Project Name  
Chazen Museum of Art Addition

SUBJECT: Chazen Museum of Art – UDC Informational Presentation

On June 4, 2008 we presented the University of Wisconsin's Chazen Museum of Art project to the UDC. At the informational presentation the Committee members made several comments related to the design. We appreciate the comments made and the ideas forwarded and have worked to incorporate these comments into the design as it has progressed. Please find below a summary of the comments made at the meeting and our teams response:

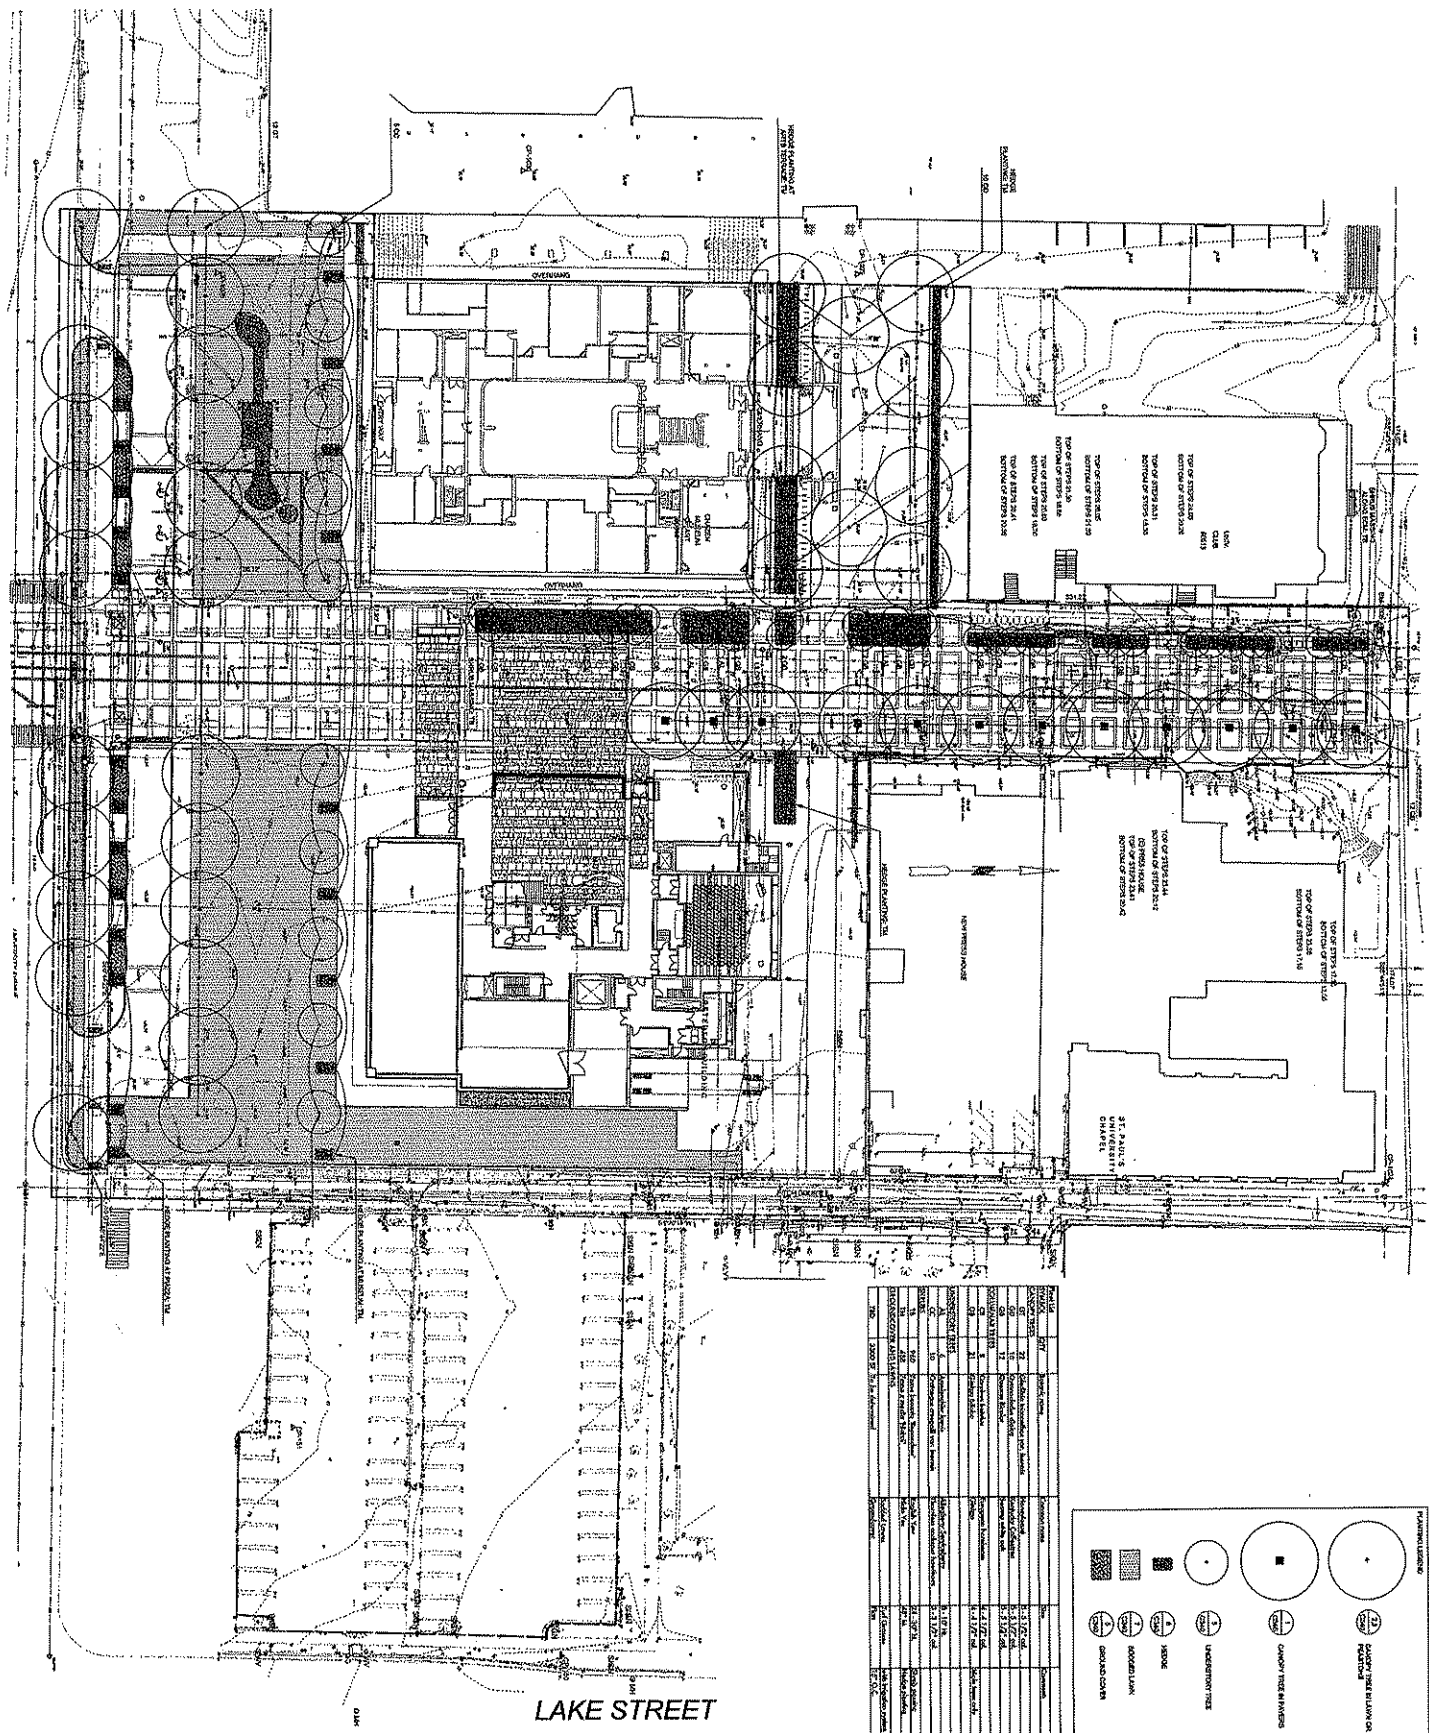
Comment 1: "There does not appear to be much green space on the site plan, there is a lot of hardscape." Response: It is true that there is a lot of hardscape on the site. This is necessitated by the need to maintain emergency egress along the entire length of the pedestrian mall and along the entire north side of the Chazen museum. Even though Murray street will be converted to function primarily as pedestrian mall, fire trucks and occasional delivery trucks will need to use the mall to provide services to the University Club and the Pres House residence and chapel at the north end of the site. The design team has developed a landscape plan that is appropriately urban and in context with the other developments along the East Campus Mall; the necessary and functional hardscape elements are pedestrian scaled, through the use of colored concrete and stone pavers rather than asphalt and concrete pavings. The new site will contain approximately 65 more trees than currently exist on the site for a total of just over 100. In addition we have changed several areas of hardscape, including the entire drop off area from standard concrete pavers to pervious type concrete pavers. The result is a total decrease on the site in the amount of storm water being fed into the City storm system.

Comment 2: "Will the tail of the bus swing into the bike lane as it turns into the drop off area?" Response: The turn radius into the drop off area will be made wide to limit the swing.

SOUTH ELEVATION

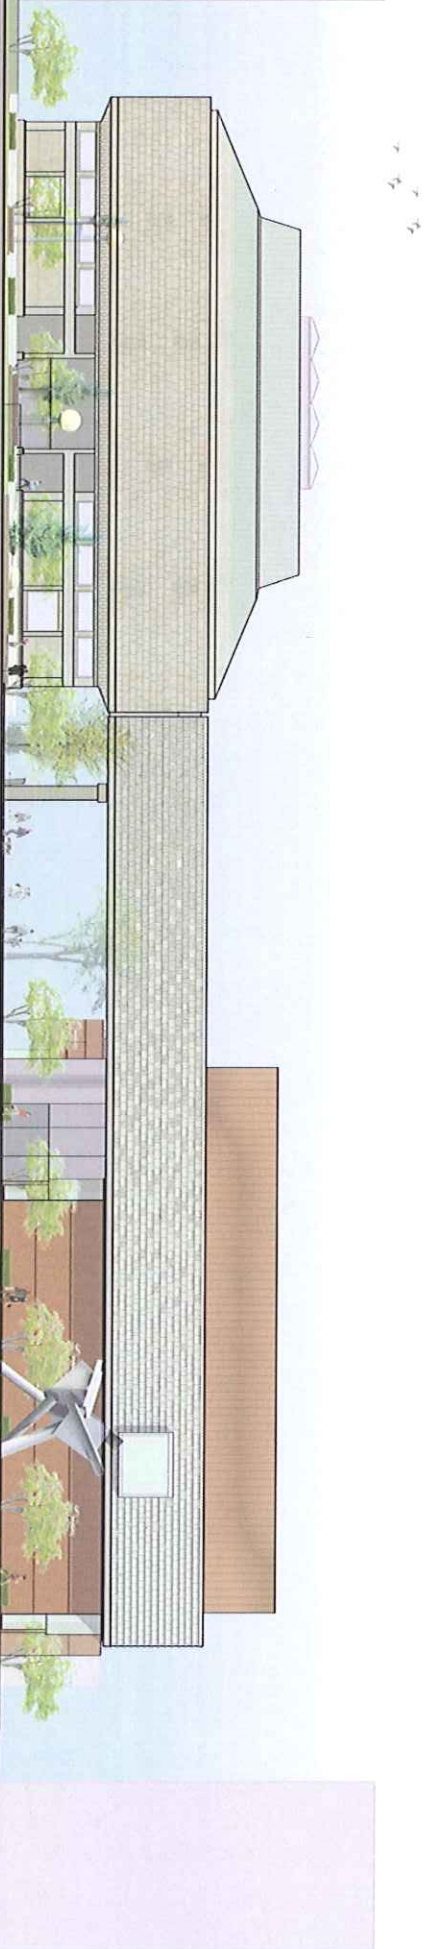
Comment 3: "South elevation: can there be more windows in the bridge?" Response: The majority of the north side of the bridge will be glass. This will allow for views north to the lake. The south side of the bridge cannot have any windows added as this is major gallery space. Light cannot be allowed into this gallery space as it is very detrimental to the artwork on display within the gallery.

Comment 4: " South elevation: can the one window in the south elevation stick out farther. It would be more dramatic and provide for better art piazza views to the west and east". Response: This is a great idea. We have increased the projection of the window to 2'-0".

NORTH ELEVATION

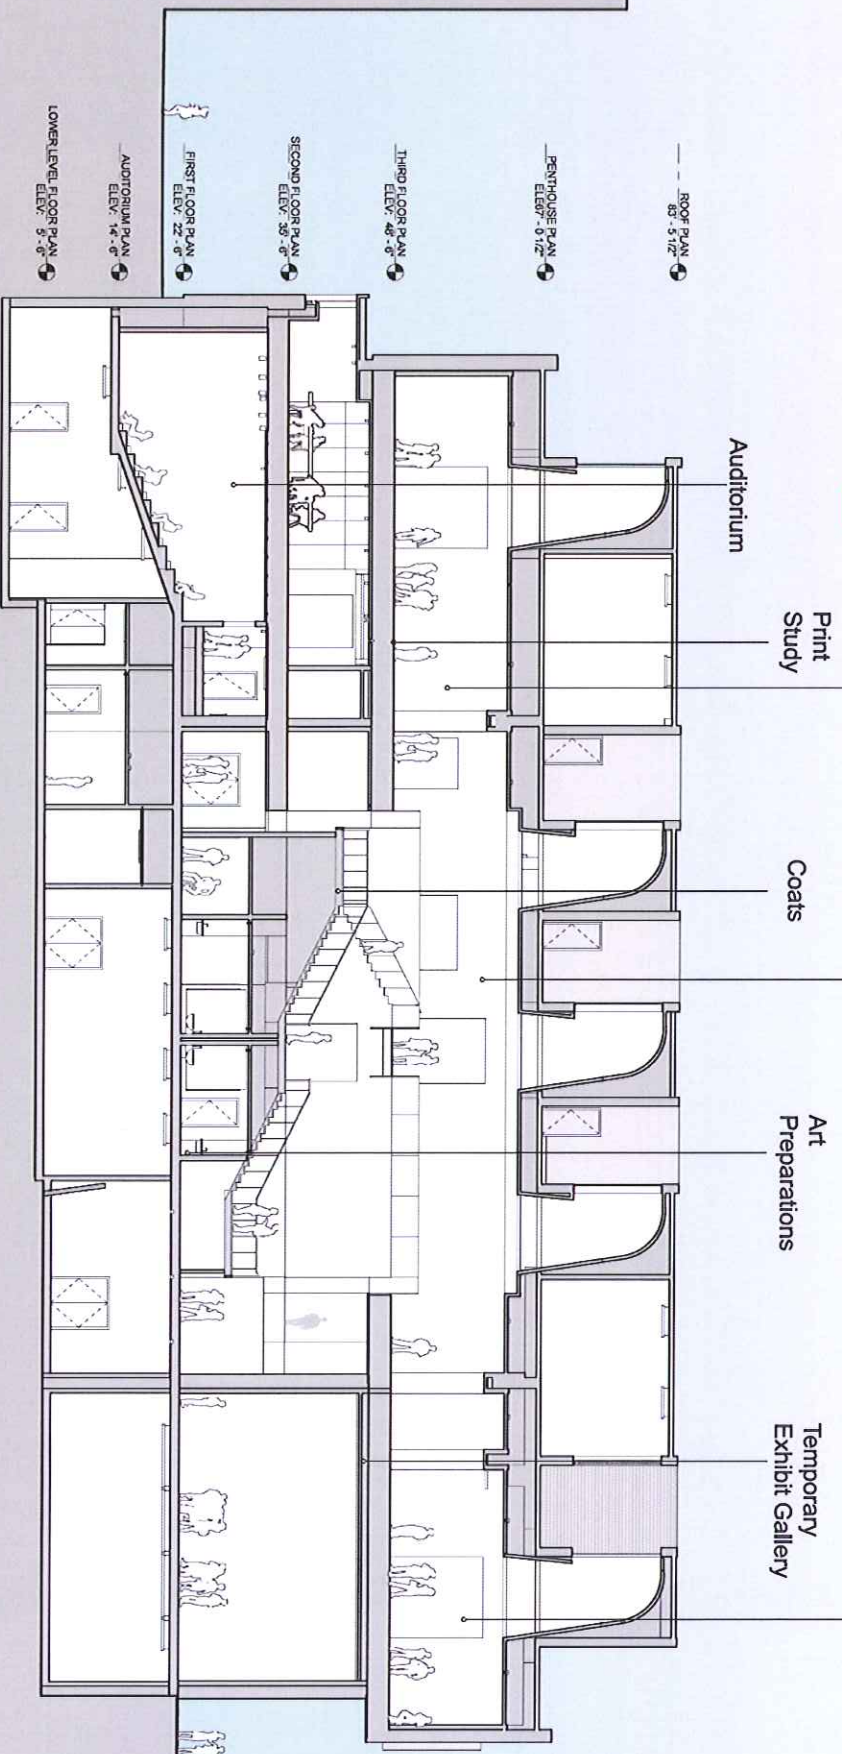
Comment 6: "The north elevation is unresolved and does not make sense. Using concrete just because it is cheaper is not a good reason. Do you really need this loading dock? What else happens here to justify this back of house approach?"

Response: The presentation materials did not include a perspective at the back of the building which made it difficult for the committee to understand the massing. The concrete used will be highly detailed and refined and was chosen not for cost but for function and aesthetic preference, as a way to delineate one mass from the adjacent masses. We will include a perspective at the Plan Commission meeting which will clarify the massing in this area. The loading dock is a very necessary component of the museums operations. In addition, this area behind the building will function as a loading area, fire truck access and service court for the Pres house and the future music building and as a pedestrian pathway. In addition to the architectural concrete on the building, the walkways and drives will include a variety of patterned, colored concrete pavers.

COLUMN STUDY

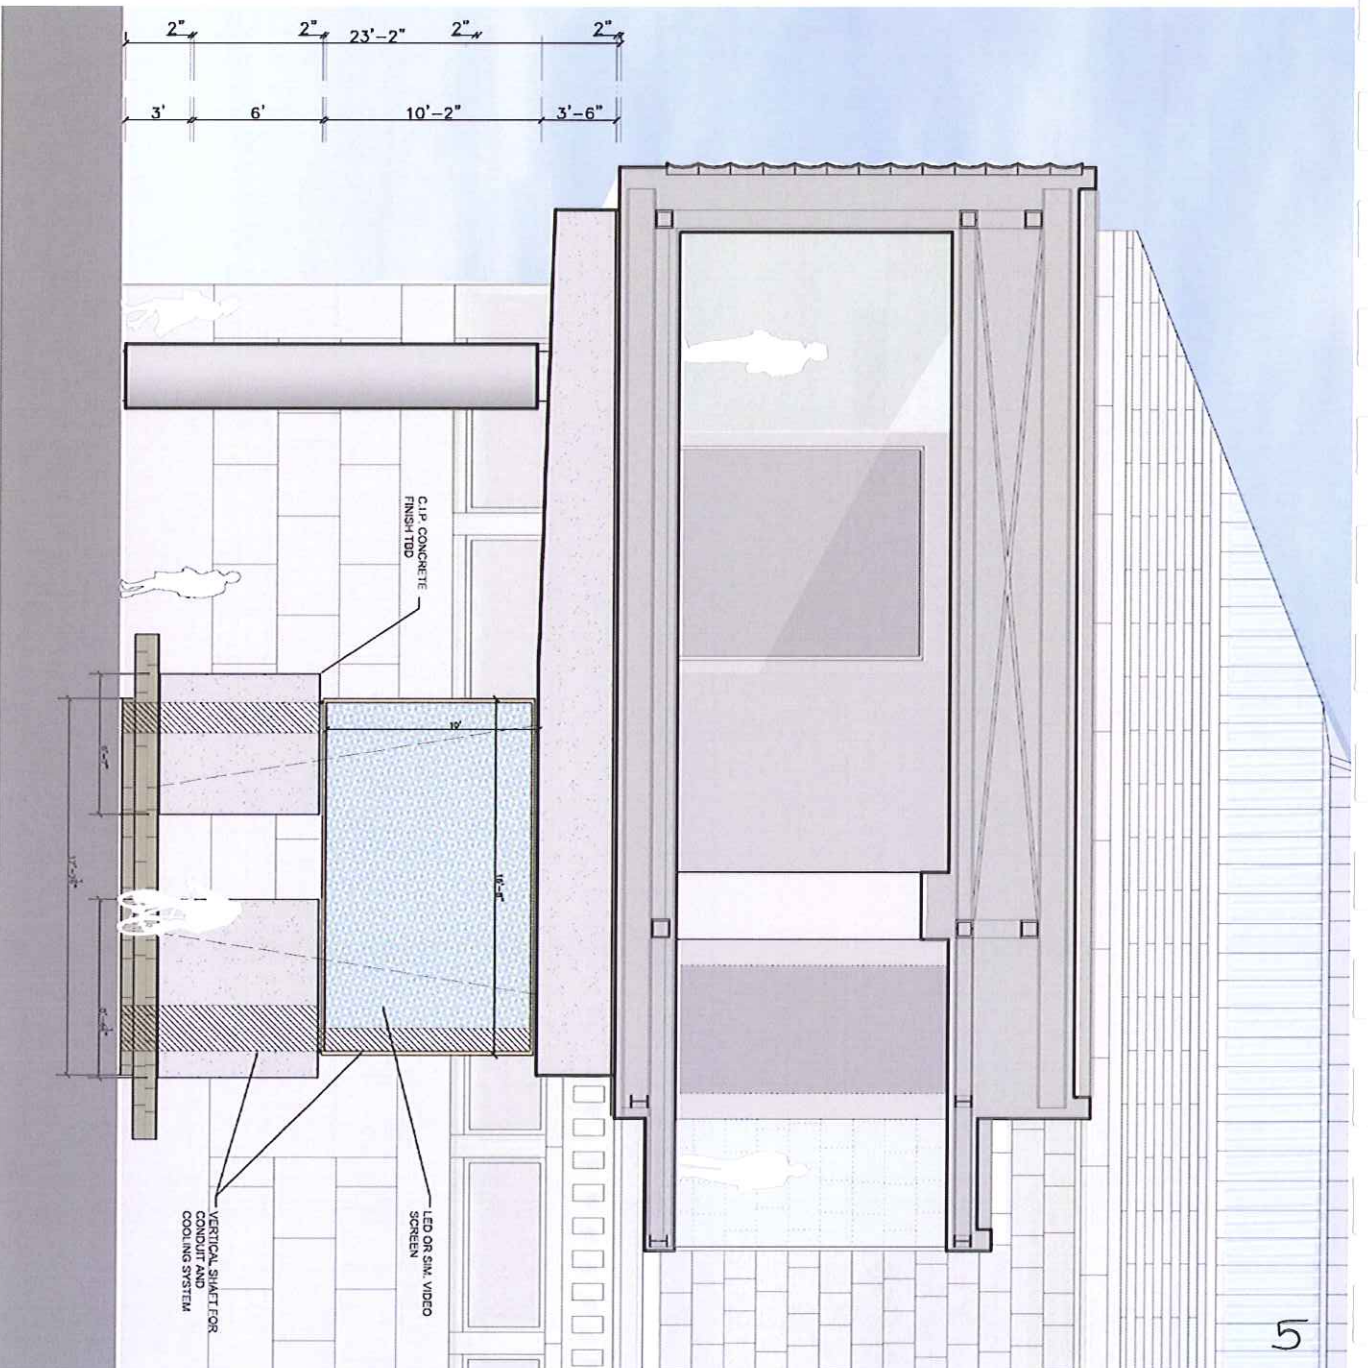
Comment 7: "The column looks unresolved". Response: The column was unresolved at the time of the presentation. The design team is continuing to work on the resolution and detailing of the column and will provide an update at the Plan Commission presentation.
